**Freightliner
Service Bulletin**

On Cascadia vehicles built with wiper motors installed before 2/2/2017, the wiper park brush that rides against the brush plate may wear, which may result in a diminished wiper park signal.

Wiper Motor Inspection and Replacement

Fig. 2, Rain Tray, Center Section

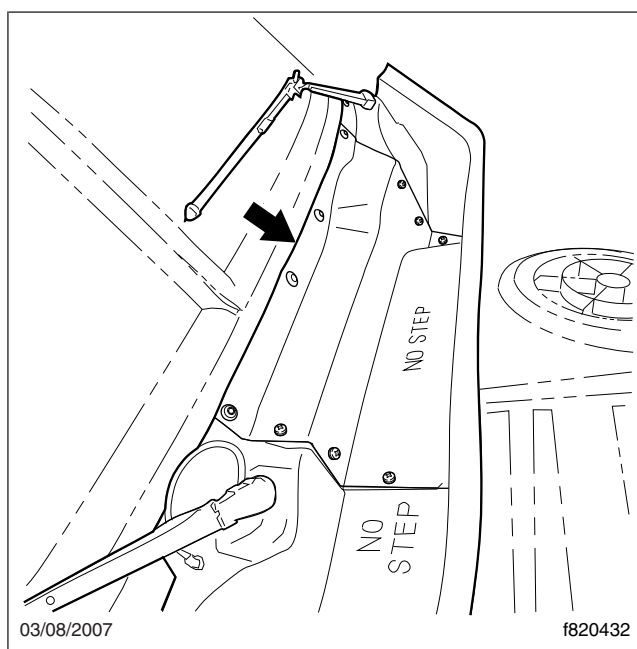
4. Disconnect the batteries.
5. Remove the center section of the rain tray by removing the fasteners that attach it to the windshield support and to the left-side and right-side sections of the rain tray; see [Fig. 2](#).

12. Install the center section of the rain tray by attaching it with the fasteners to the windshield support and to the left-side and right-side sections of the rain tray; see **Fig. 2**. Tighten the screws that attach the rain tray to the windshield support 8 to 12 lbf-ft (11 to 16 N-m). Ensure that the tray seals evenly with the cab, with no gaps.

Fig. 3, Wiper Motor Installation

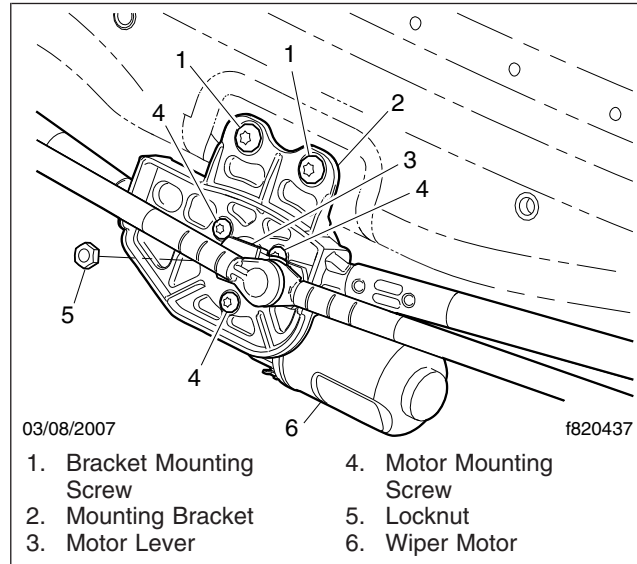
7. Remove the nut that attaches the motor lever to the motor shaft; see [Fig. 3](#).
8. Remove the three screws that attach the motor to the mounting bracket. Remove the motor.

9. Attach the new motor (p/n TRI F91498 495) to the mounting bracket with three screws. Tighten the screws 8 to 11 lbf-ft (11 to 15 N-m).
10. With the linkage in park position, as shown in **Fig. 3**, install the nut that attaches the motor lever to the motor shaft. Tighten the nut 15 to 18 lbf-ft (20 to 24 N-m).
11. Connect the wiper motor electrical connector.

Fig. 4, Windshield Wiper Park Position

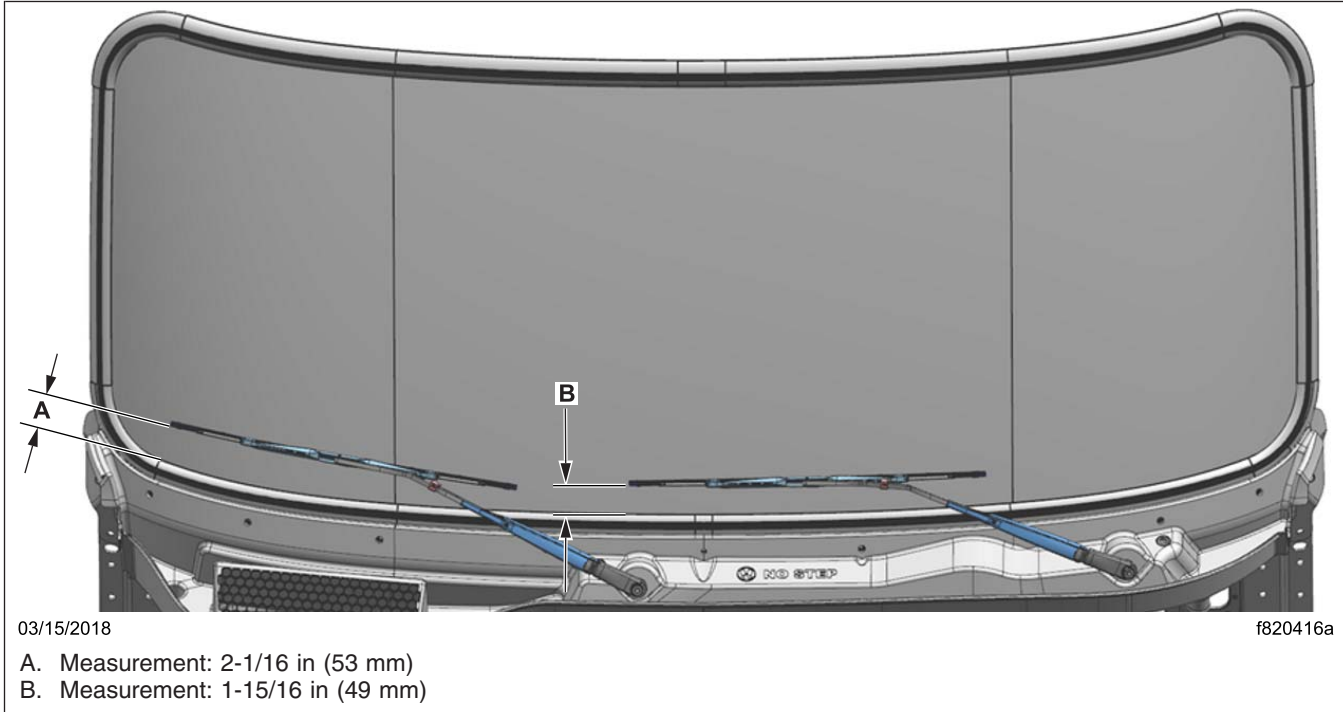
14. Connect the batteries.
15. Test the wiper motor and washers. Operate the wipers at low speed and check that the blades do not slap against the mask around the edge of the windshield, and that the wipers park as shown in **Fig. 4**. In the parked position, the end of the right-hand wiper blade should be 2-1/16 inches (53 mm) above the bottom edge of the windshield, and the end of the left-hand wiper blade should be 1-15/16 inches (49 mm) above the bottom edge of the windshield.
